**RE: Noah's Event Center
Vista Fuentes Rd NW
Grading and Drainage Plan
Engineers Stamp Date 4/14/15 (C12D003B4)**

TITLE: **VISTA FUENTE ROAD IMPROVEMENTS**

VALLEY GUTTER #2
NTS

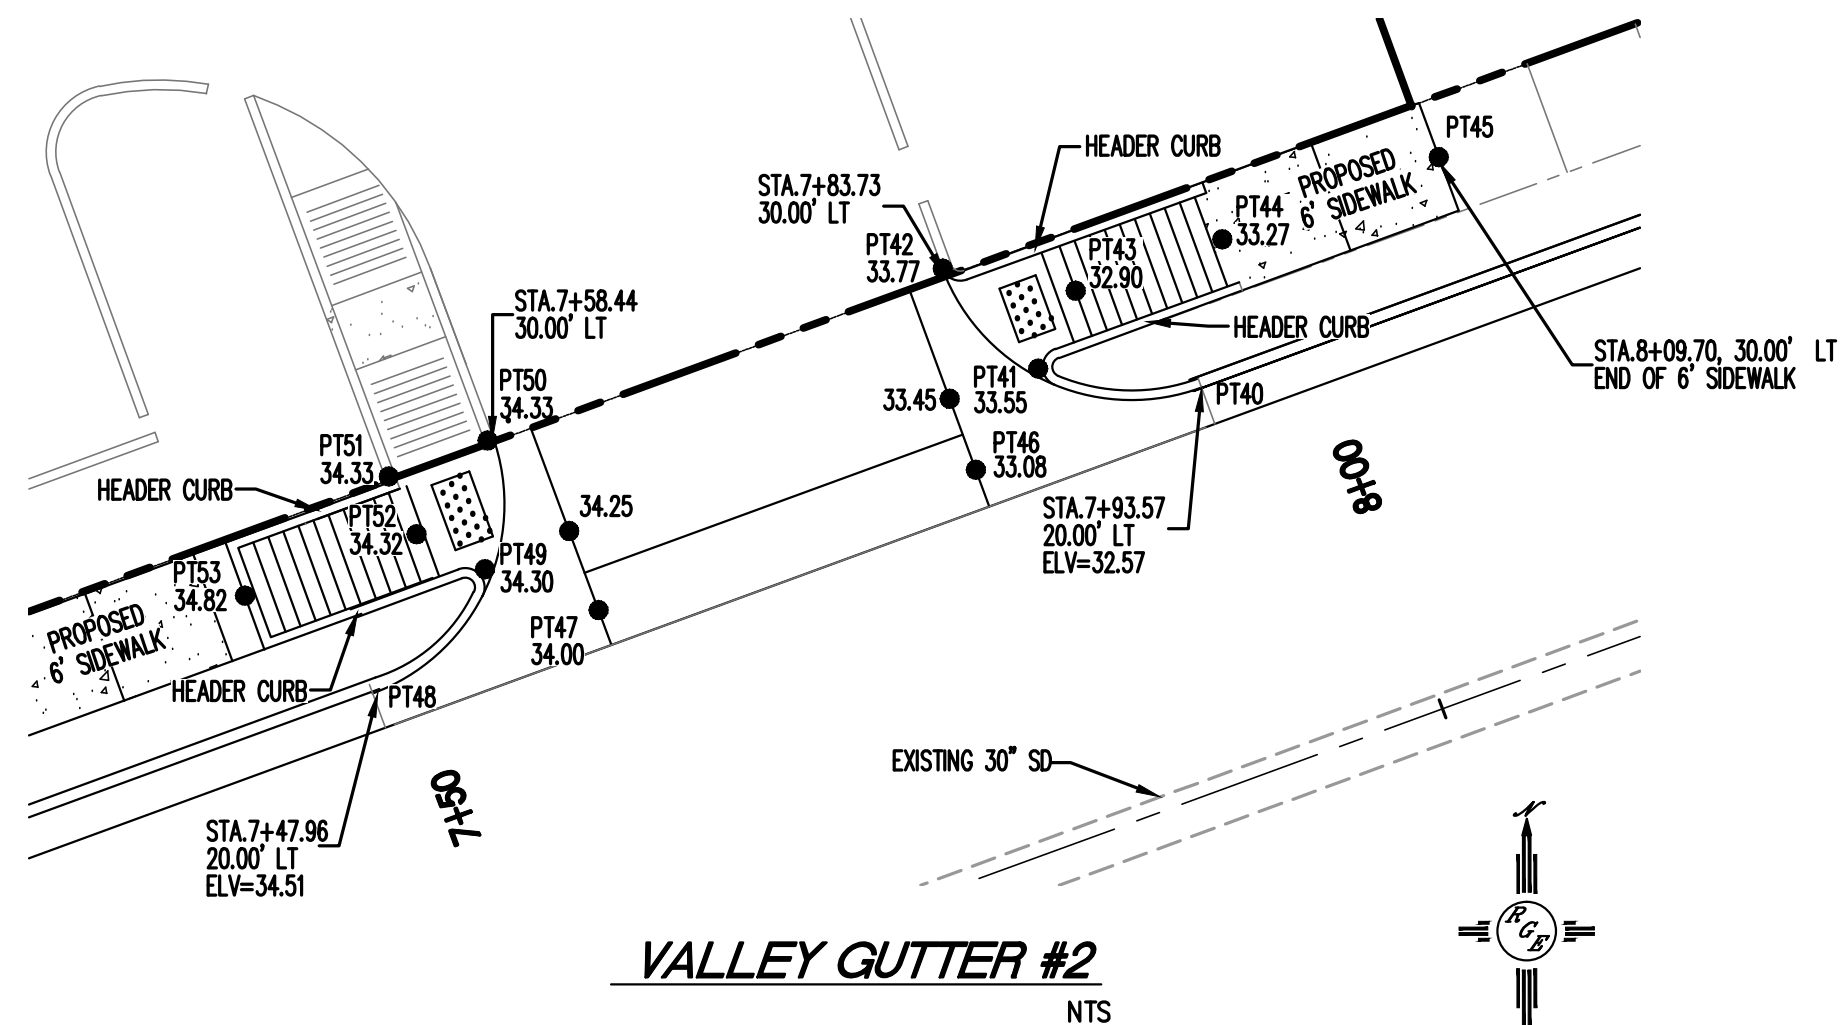
my misspelling....
should be "details".

Dan, we will need to make room for the catch basin
details... the type "A" with two grates.
